# A303 STONEHENGE AMESBURY TO BERWICK DOWN

## Stage 1 Road Safety Audit

**PROJECT NO. 70200002-142  
OUR REF. NO. ITS/447/2018**

**DATE: JULY 2018**

## **PROBLEM LOCATION PLAN**

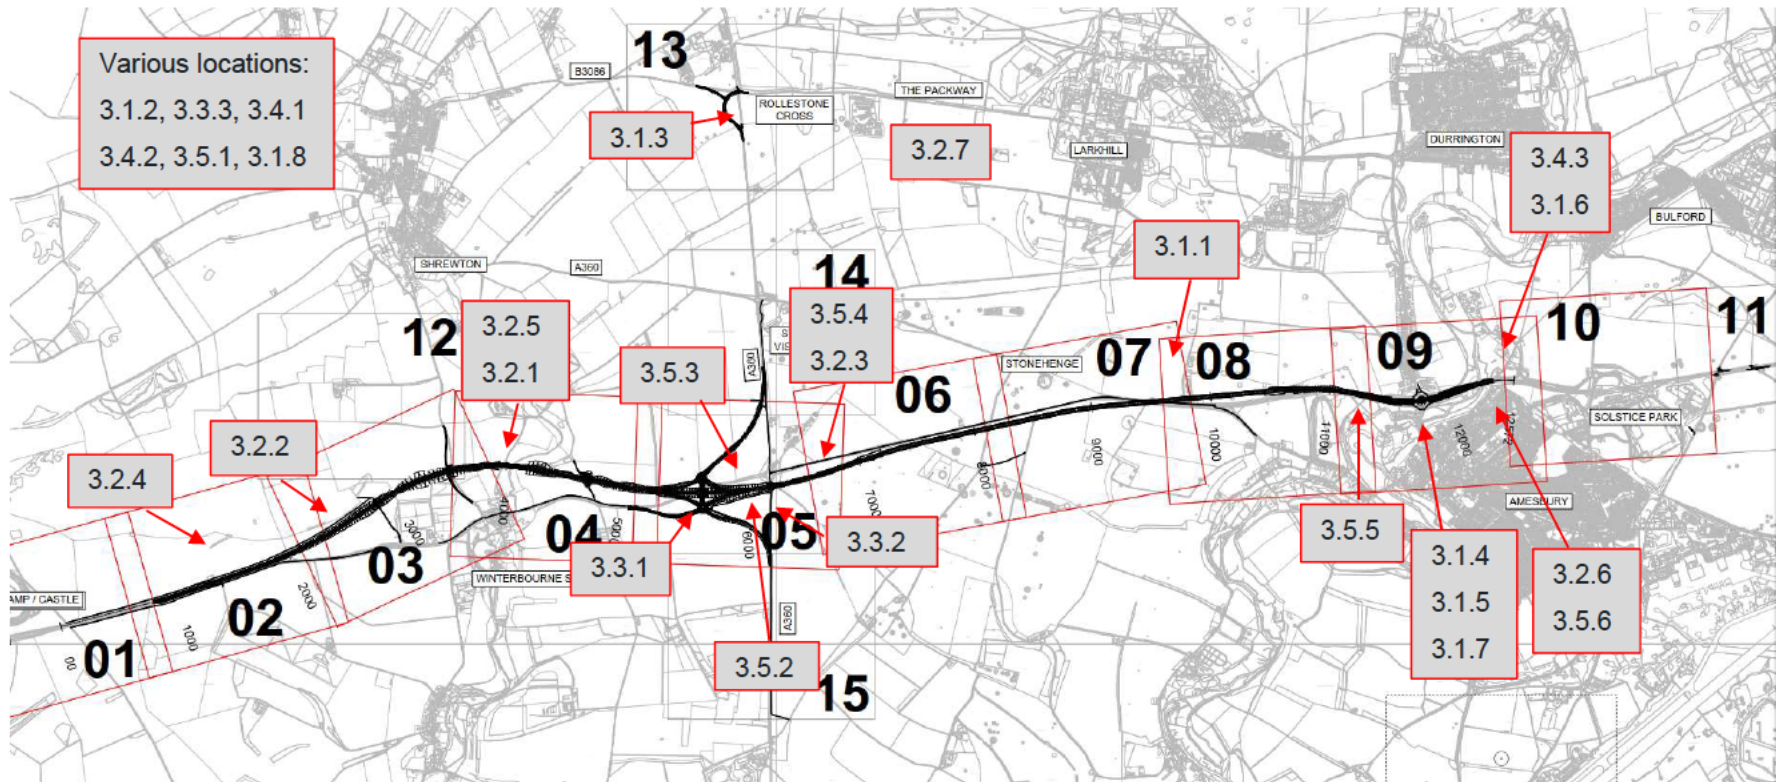
**Detail:** Within the proposed tunnel, there are a number of cross passages at regular intervals to aid in the safe passage of drivers/passengers who have either been involved in a collision or have broken down. However, there doesn't appear to be safe waiting area for pedestrians to use an emergency telephone in the event of a collision or breakdown. The pedestrian would therefore be required to wait within the tunnel, adjacent to the live running lanes whilst using the emergency telephone. The lack of a safe waiting area would increase the risk of the pedestrian being involved in a secondary collision, being struck by a passing vehicle or of their broken down vehicle being struck by another vehicle which subsequently collides with the pedestrian/s.

**Detail:** The proposed route of the A303, dissects a number of local roads, byways and public rights of ways. Where the A303 dissects these routes, they are to be closed to all users. There is a risk that users may attempt to continue across the A303 as they are unaware of alternatives where there is a risk of collision with vehicles on the A303.

**Detail:** The proposals include alterations to the Rollestone Crossroad junction, to allow effective operation when this route is required as a diversion route due to tunnel closure. The proposals include amendments to the existing crossroads and changes to priorities. However, the junction of the B3086 and Packway is now a T-junction located on a bend. On this bend, visibility when attempting to enter the main road from the side road may be restricted due to the vertical alignment of the carriageway resulting in vehicles pulling out into the path of other vehicles resulting in a T-bone type collision. Also any vehicle waiting to turn right into the side road, may be at risk of a shunt type collision due to the possible restricts of forward visibility.

**Detail:** The proposed mainline on approach to the Countess Junction westbound diverge (Lane 1) is three steps below the required stopping sight distance. There would be a risk of vehicles colliding with the rear of queuing traffic due to the reduction in stopping sight distance resulting in a shunt type collision.

**Detail:** The proposed mainline on approach to Countess Junction eastbound merge (Lane 2) is three steps below the required stopping sight distance. There would be a risk of vehicles colliding with the rear of queuing traffic due to the reduction in stopping sight distance resulting in a shunt type collision.

**Detail:** The proposed Eastern Tie-In is three steps below the required stopping sight distance. There would be a risk of vehicles colliding with the rear of queuing traffic due to the reduction in stopping sight distance resulting in a shunt type collision.

**Detail:** The proposed Countess Westbound Diverge is three steps below the required stopping sight distance. There would be a risk of vehicles colliding with the rear of queuing traffic due to the reduction in stopping sight distance resulting in a shunt type collision.

**Detail:** The exit visibility from the proposed lay-by does not meet requirements for major/minor junctions. Therefore should an operative or member of public stop within the layby, there would be an increased risk of a collision with approaching traffic on the A303 when exiting the layby. This could result in injuries to the occupants of the vehicles involved.

**Detail:** The proposed A303 carriageway includes the provision of Emergency Refuge Areas for drivers to use emergency telephones in the event of a breakdown. The emergency refuges (east and westbound carriageways) to the east of the B3083 underbridge appear to be located on a bend. There is a risk therefore that when vehicles attempt to exit the emergency refuge, the drivers' visibility will be restricted and therefore unable to see approaching vehicles. This may increase the risk of the vehicle exiting into the path of another vehicle on the A303, resulting in a collision.

**Detail:** The proposed A303 carriageway includes the provision of Emergency Refuge Areas for drivers to use emergency telephones in the event of a breakdown. The emergency refuges on the westbound carriageway to the west of Green Bridge No. 1 appears to be located on the exit from a bend. There is a risk therefore that when vehicles attempt to exit the emergency refuge, the drivers' visibility will be restricted and therefore unable to see approaching vehicles. This may increase the risk of the vehicle exiting into the path of another vehicle on the A303, resulting in a collision.

**Detail:** The proposed A303 carriageway includes the provision of Emergency Refuge Areas for drivers to use emergency telephones in the event of a breakdown. There are a number of signs located within the highway verge downstream of the proposed emergency refuge on the eastbound carriageway to the east of Green Bridge No. 4. The signs are Lane Control x2 and a tunnel warning sign accompanied by a 'Stop when lights are lit' sign. There is a risk therefore that when vehicles attempt to exit the emergency refuge, the drivers' visibility will be restricted and therefore unable to see approaching vehicles. This may increase the risk of the vehicle exiting into the path of another vehicle on the A303, resulting in a collision.

**Detail:** Toward the western extent of the scheme, it is proposed for a 'New Road Layout Ahead' sign to be provided. However, the sign is not located prior to the start of the scheme extents. Therefore drivers may not be fully aware of the proposed emergency refuge area or any other proposed alterations to the carriageway in its vicinity.

**Detail:** On the A303 eastbound carriageway to the west of Green Bridge No.2, there are proposals for a large (6.7m x 5.9m) advance directional sign (ADS) and then a large (5.6m x 4.5m) Tunnel Ahead prohibited traffic sign positioned closely after. There is a risk that the large ADS will mask the information on the Tunnel Ahead prohibited traffic sign due to their close proximity to each other. This could result in drivers failing to fully comprehend the information on the prohibition sign resulting in a prohibited vehicle type, cyclist or horse rider entering the tunnel where there is a high risk of collisions with other motor vehicles.

**Detail:** On the A303 westbound carriageway to the west of its junction with the Countess Junction, there are a large quantity of signs, located within close proximity of each other. Within a relatively short distance there are the following signs:

**Detail:** The proposed local diversion (should the tunnel be closed) is to direct traffic along the A360, through Larkhill and then re-join the A303 on the A345 (and vice versa). Diamond diversion symbols are being proposed at the A303 junction at each of the diversion route, whilst no details of the signing was included in the drawings for the remainder of the diversion route. The diversion route includes a number of turning manoeuvres at junctions and failure to provide adequate diversion route signing may result in drivers becoming hesitant resulting in shunt type collisions.

**Detail:** The scheme proposes bridleway crossings over the realigned A360 south link and the Longbarrow to existing A303 link arms of the Longbarrow Junction. The proposals also show that a bridleway is proposed around part of the southern roundabout of the Longbarrow Junction, adjacent to the carriageway. There is a risk of horse becoming spooked and/or being struck by vehicles whilst attempting to cross the carriageways at this junction.

**Detail:** The existing A360 is to be stopped up and converted into a bridleway, cycle track and private means of access. This proposed facility is to be 4 metres in width. There are accesses to this facility from the realigned A360 to the north and the realigned A360 to the south. The facility bypasses the proposed Longbarrow junction completely and there is a risk of drivers attempting to use the facility in order to bypass the Longbarrow junction. If a vehicle were to drive along this facility at high speeds there is a risk of collision with horse riders, cyclists, walkers or other vehicles.

**Detail:** There are a number of underpasses to be created as part of this scheme where walkers, cyclist and horse riders are to use as part of their routes. Failure to adequately light these underpasses could deter WCH from using them and then seeking out an alternative, less safe route or they could present a risk to the personal safety of the users should they be un-illuminated during hours of darkness.

**Detail:** There are a number of balancing ponds and infiltration basins alongside the proposed route of the new A303. These ponds/basins may become full of water at times of heavy rain. Walkers may pass close to these ponds/basins and there is a risk that a walker may either inadvertently fall/slip into the water where they could drown.

**Detail:** The drainage details shows there is to be a 'V' channel covered in grass between the edge of the carriageway and the verge. If the 'V' channel is located close to the edge of the carriageway, drivers may unintentionally drift off the carriageway and into the 'V' channel which may result in the vehicle losing control.

**Detail:** The super elevation at the East Tie-In is proposed to be three steps below the desirable minimum. If the superelevation is insufficient, there is a greater risk of standing water on the carriageway increasing the risk of vehicle skidding on the water or ice (should it freeze). The loss of control is likely result in injury to the vehicle occupants or of any other vehicle involved in a collision.

**Detail:** The road restraint system (RRS) drawing don't appear to make reference to the type of end they are to be constructed with. If a 'ramp-end' type is used then should a vehicle lose control and strike the end of the RRS, the vehicle could be launched resulting in a higher severity of injury suffered by the vehicle occupants. If P4 terminals are used throughout the scheme where-ever possible, this risk of a vehicle being launched is mitigated/greatly reduced.

**Detail:** The proposed Longbarrow Junction is elevated above the level of the A303. The slip roads therefore are on embankment to bring the A303 traffic up to the level of the junction. The A303 westbound off slip to the Longbarrow junction appears to at the top of an embankment of considerable height. RRS is not being provided for this embankment and should a vehicle leave the carriageway at this location, there is a risk of the vehicle overturning and rolling down the embankment, causing serious injuries to the vehicle occupants.

**Detail:** The proposed Longbarrow Junction is elevated above the level of the A303. The slip roads therefore are on embankment. The A303 eastbound onslip slip at the Longbarrow junction appears to at the top of an embankment of considerable height. RRS is partially being provided along the top of the embankment however there is a considerable gap in RRS between the A303 mainline carriageway and the slip road itself. Should a vehicle leave the carriageway at this location, there is a risk of the vehicle overturning and rolling down the embankment, causing serious injuries to the vehicle occupants.

**Detail:** There is proposed RRS alongside the A303 eastbound carriageway to protect vehicles from colliding with the bridge supports for Green Bridge No.4. There is a then a short gap in RRS before commencing once again to protect signs located within the verge. This short gap could present an un-necessary hazard to road users. Should a vehicle lose control at this location and leave the carriageway it may pass through the gap in RRS or strike the RRS terminal, both of which may increase the severity of any injuries suffered to the vehicle occupants.

**Detail:** Throughout the A303 on its westbound carriageway to the west of Amesbury, there is RRS proposed within the nearside verge. At the location of the Emergency Crossover there appears to be a parking area (similar to an emergency refuge area) where there is a gap in the RRS which would allow pedestrians to walk through into the adjacent fields. There is a risk of the pedestrians falling down embankments, ditches, broken manholes etc should they be encouraged to walk through onto the adjacent land.

**Detail:** There is proposed RRS alongside the A303 westbound carriageway. It is unclear what this section of RRS is protecting. If unnecessary, this section of RRS could present an un-necessary hazard to road users. Should a vehicle lose control at this location and leave the carriageway it may strike the RRS terminal and increase the severity of any injuries suffered to the vehicle occupants.

Either provide safe waiting areas for pedestrians to stand and use an emergency telephone (should they be on the nearside of the tunnel carriageway) or direct pedestrians towards the cross passages and provide safe waiting areas and emergency telephones within the cross passages.

Provide and adequately sign diversion routes for all WCHAR routes which are to be dissected by the A303.

Adequate forward visibility must be maintained throughout this junction to ensure vehicles travelling at speed are capable of stopping should a vehicle be either stationary within the carriageway or pulling out of/into the side road.

Adequate forward visibility should be maintained throughout this junction to ensure vehicles travelling at speed are capable of stopping should another vehicle be stationary within the carriageway.

Adequate forward visibility should be maintained throughout this junction to ensure vehicles travelling at speed are capable of stopping should another vehicle be stationary within the carriageway.

Adequate forward visibility should be maintained to ensure vehicles travelling at speed are capable of stopping should another vehicle be stationary within the carriageway.

Ensure the signage is located to provide adequate visibility, allowing drivers to safely re-join the A303 should they need to stop in the emergency refuges.

Provide adequate diversion route signage through-out the proposed diversion route.

Provide suitable fencing to help deter walkers from entering the ponds/basins and provide life saving devices along the banks/edges.

Provide edge of carriageway markings, positioned a suitable distance from the edge of the carriageway, to help deter/prevent vehicles from encroaching into the 'V' channel.

Review the need for this section of RRS and remove if deemed unnecessary.
